AMENDMENTS TO THE DRAWINGS:

The attached sheets of drawings include changes to FIGS. 1, 2 and 4. These sheets, which include FIGS. 1 through 8, replace the original sheets including FIGS. 1 through 8. In FIG. 1, element 90 with accompanying lead line has been added. In FIG. 2, element 210' with accompanying lead line has been added. In FIG. 4, element 90 with accompanying lead line has been added and element 104 has been revised in placement.

Remarks

element
90
added

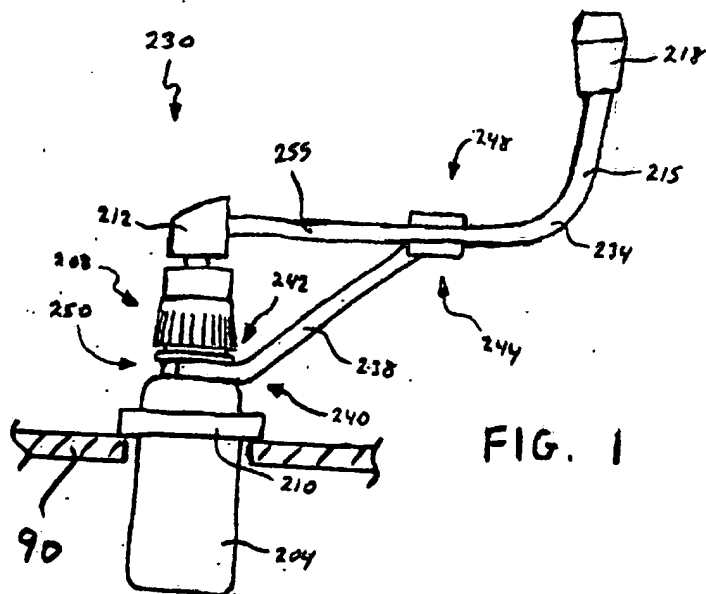
The objection to the drawings under 37 C.F.R. 1.83(a) is believed to be mooted by submission of the attached replacement sheets. As indicated in red, replacement sheet 1 / 2 includes the addition of a proposed resilient ring 210 disposed at a second position and indicated by numeral 210' in FIG. 2. Support structure 90 is proposed to be added to FIG. 1, in accordance with the Examiner's demand to illustrate a bottle being suspended by a resilient ring in a storage device.
